**Springfield Township
Planning Commission Meeting
March 21, 2023**

Reference: 1110 Willow Grove Avenue – Redevelopment – Application

RE: Landscape Plan Review for 1110 Willow Grove Avenue Mixed-Use Proposal

PRELIMINARY / FINAL LAND DEVELOPMENT PLAN FOR

GRADING and DRAINAGE PLAN

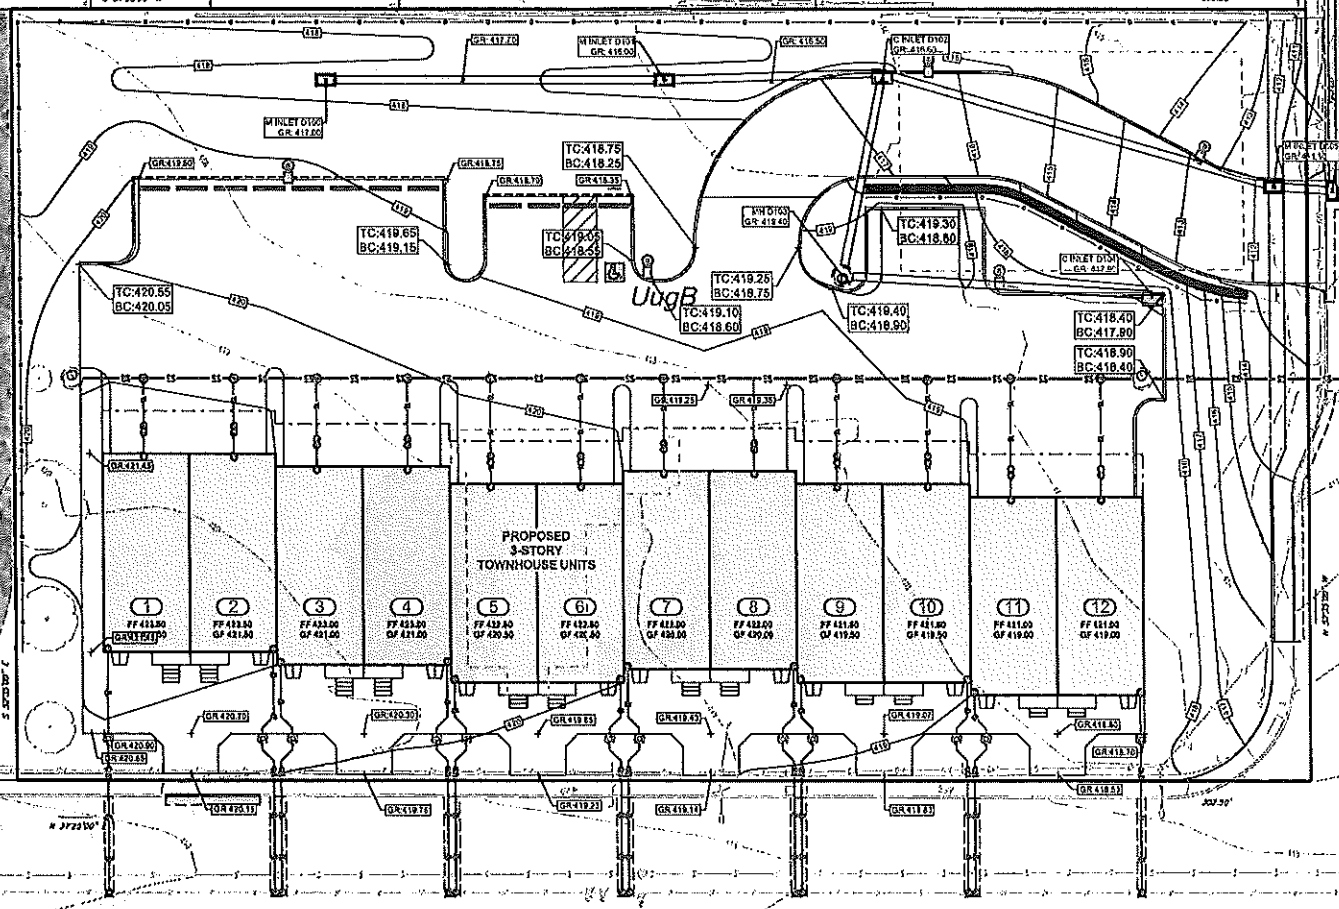
1. The applicant is proposing the connection of the storm sewer collection system from the project to existing Township infrastructure via a storm sewer extension down Queen Street to the intersection of East Pleasant Avenue.

- a. Specific topography along this stretch of roadway is required.
 - b. A profile of the storm sewer extension is required.
 - c. Investigation as to the adequacy and structural stability of the point of connection is required.

- d. Design of the restoration of curb, sidewalk and paving is required.
 - e. The existing storm sewer inlet at the intersection of Queen Avenue and East Pleasant Avenue is oddly positioned. A specific detail as to the connection methodology is required.

UTILITIES PLAN

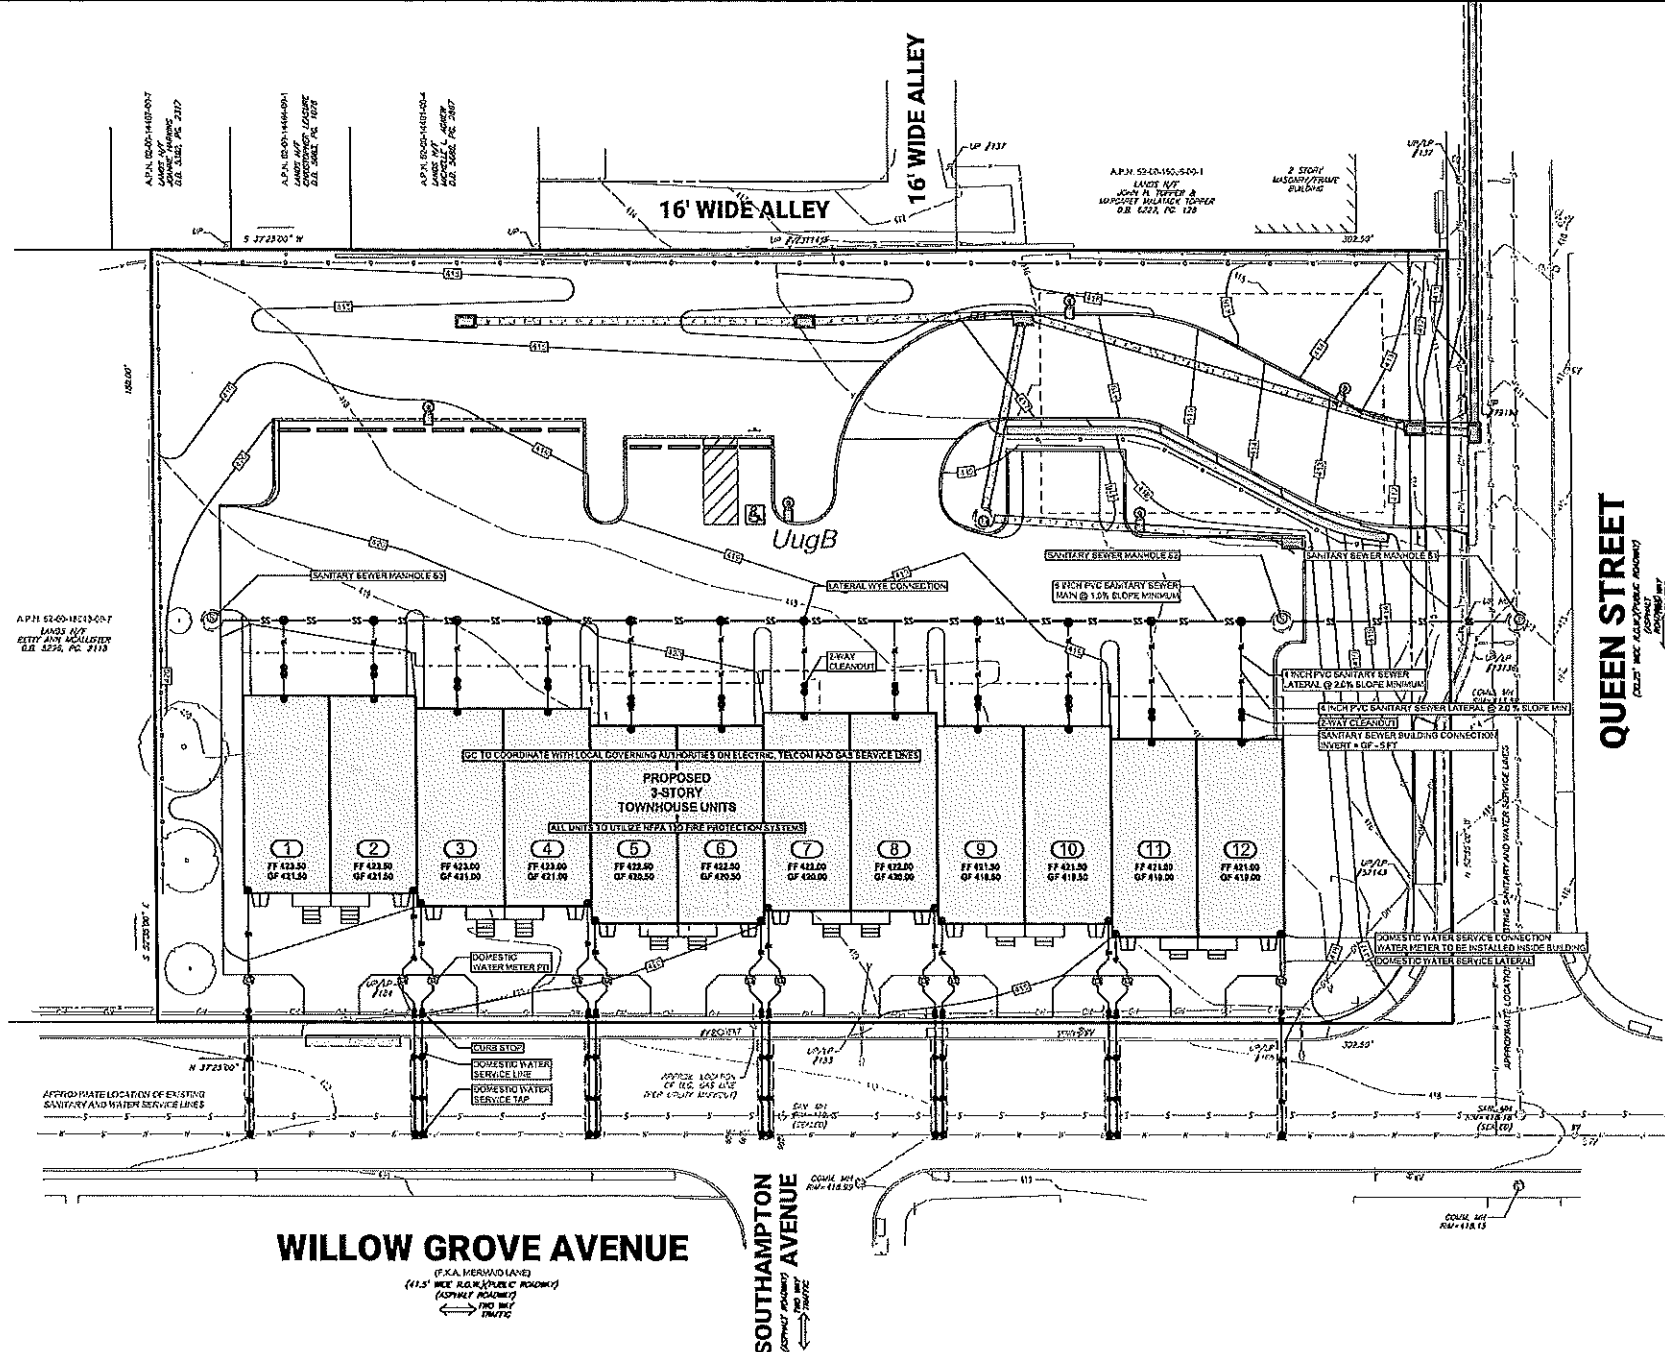
7. The depth of the sanitary sewer and Willow Grove Avenue should be shown to assure that there are no conflicts with the proposed water service laterals.

B3 FIRE TRUCK INGRESS MOVEMENT
SCALE: 1 INCH = 20 FEET

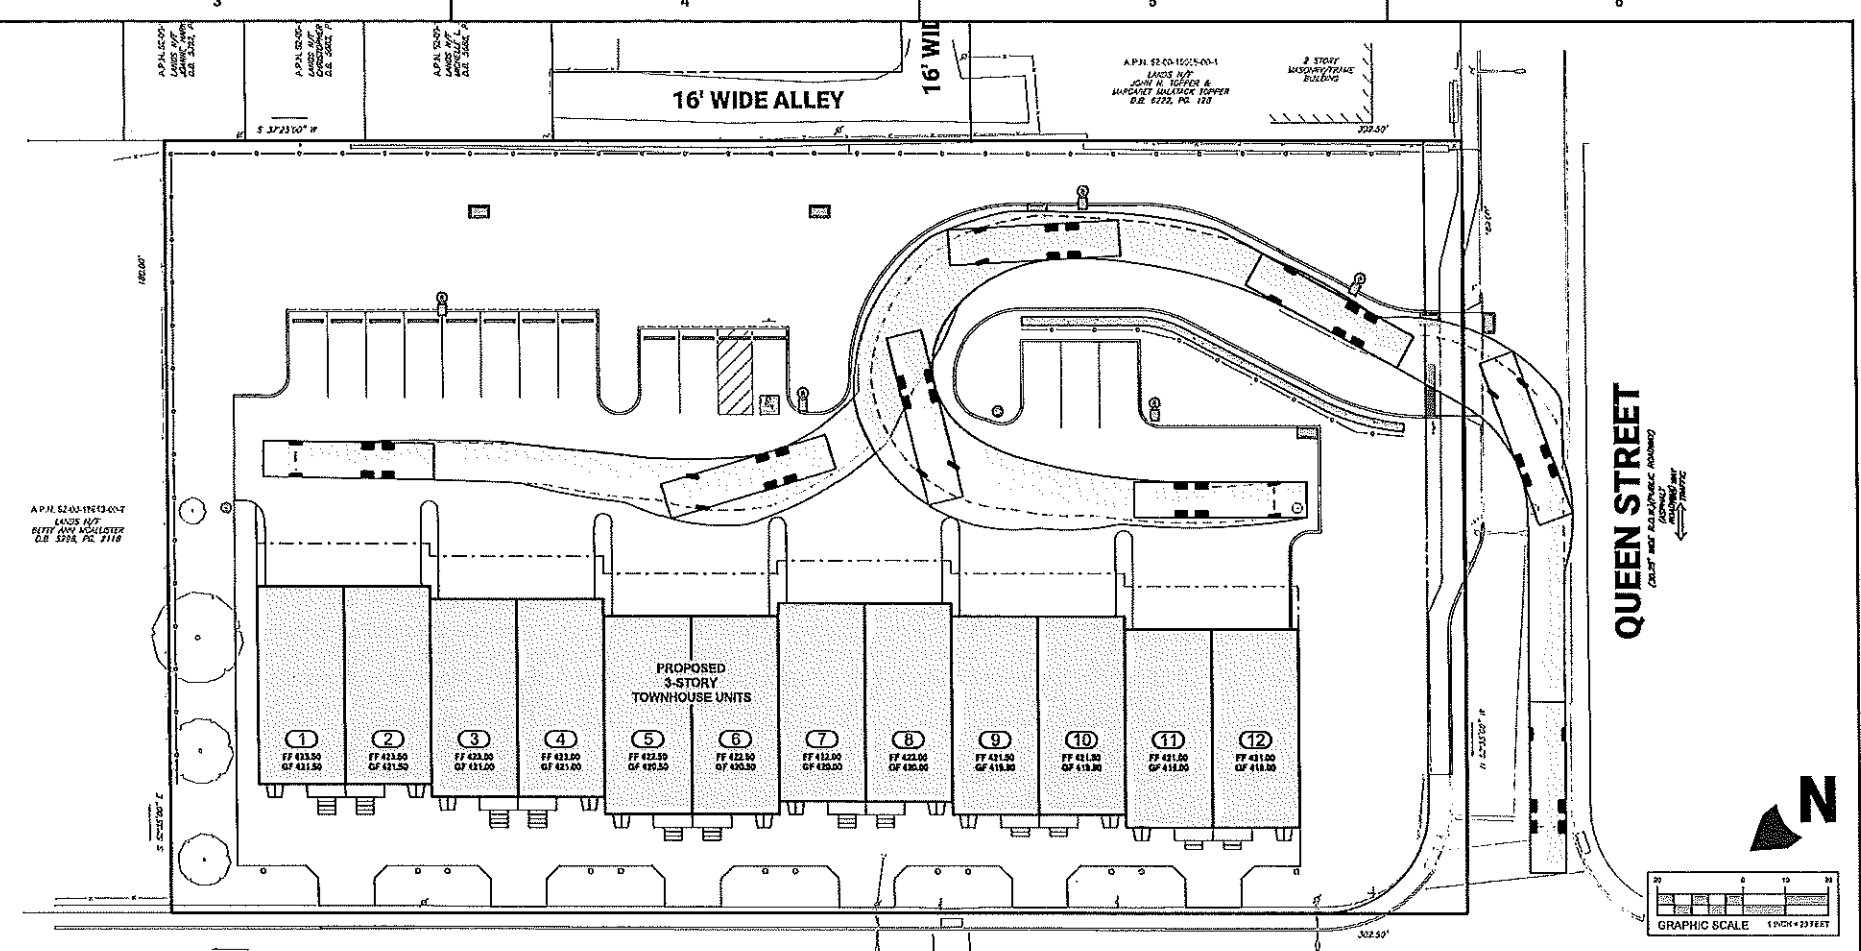
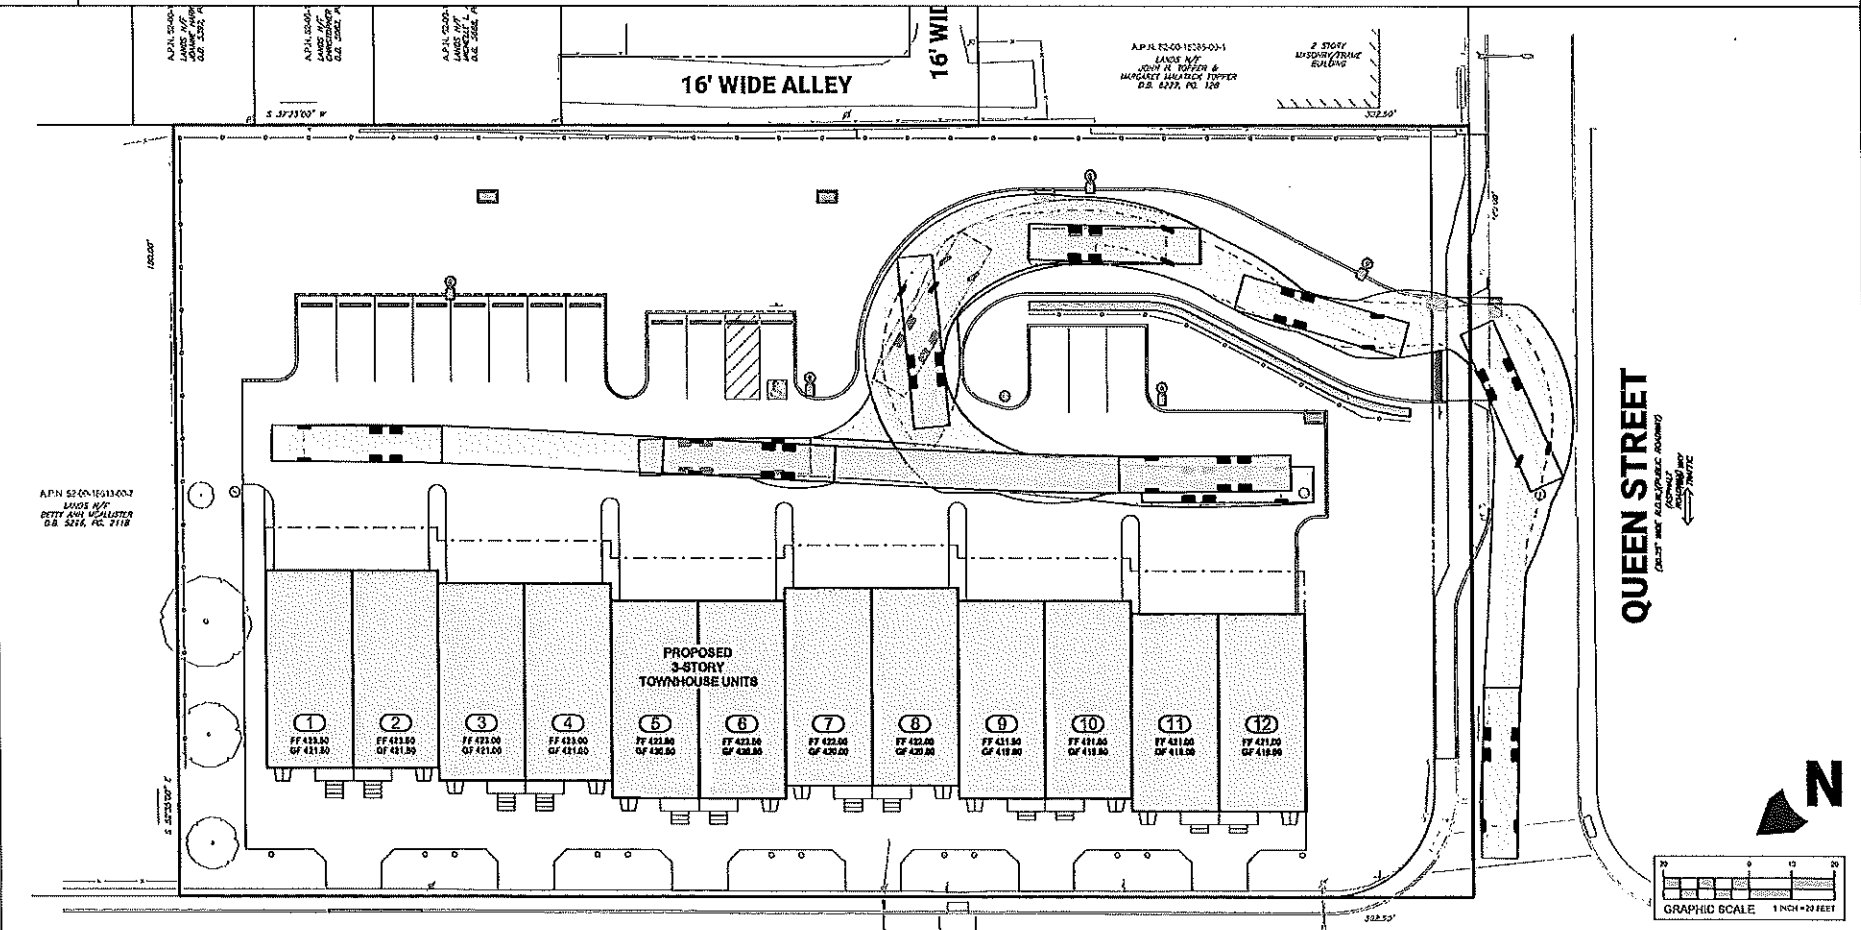
8. Parking Lot Access -- Emergency service personnel must comment specifically on their opinion as to the adequacy of the truck turning templates to facilitate their equipment in case of emergency.

LIGHTING PLAN

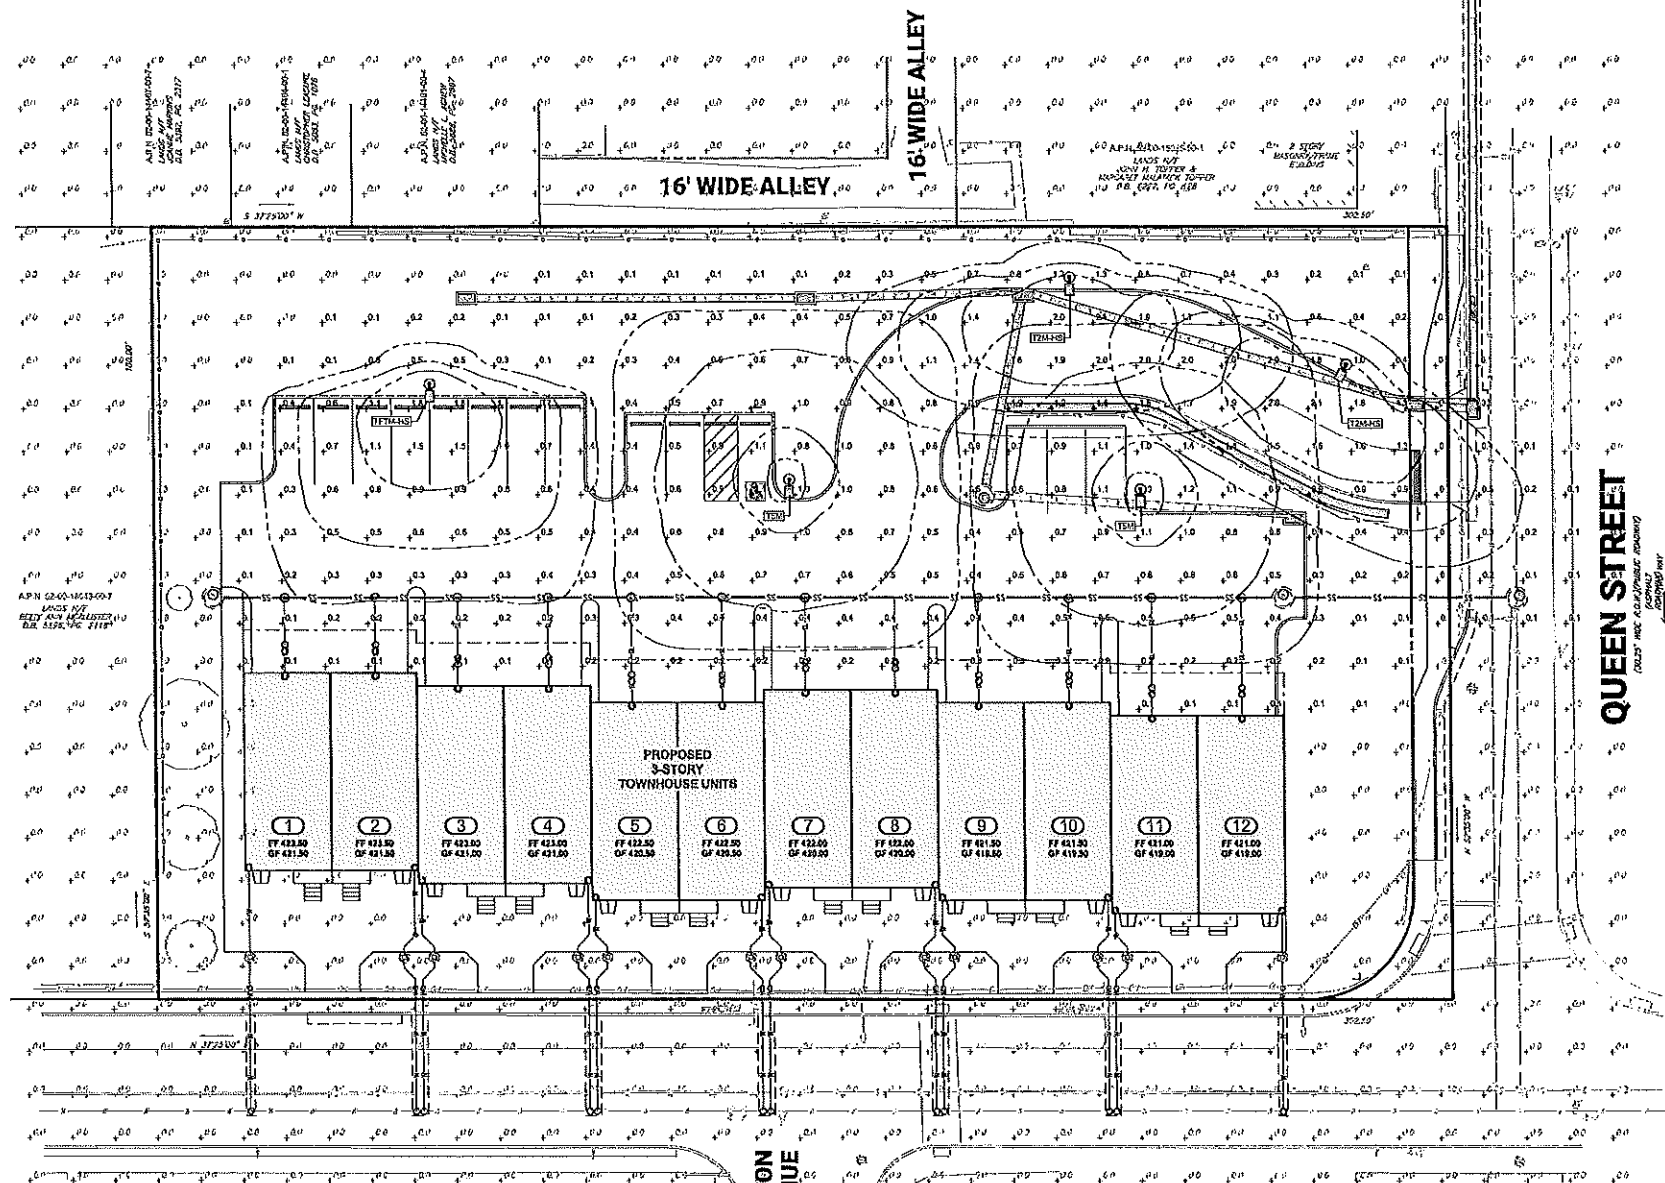
6. Site Lighting -- A note should be added to the lighting plan to indicate the following, "The Township will reserve the right to view the lighting installation at the completion of construction. If unintended light spill is encountered, additional shielding will be mandated in order to mitigate any unintended adverse impacts."
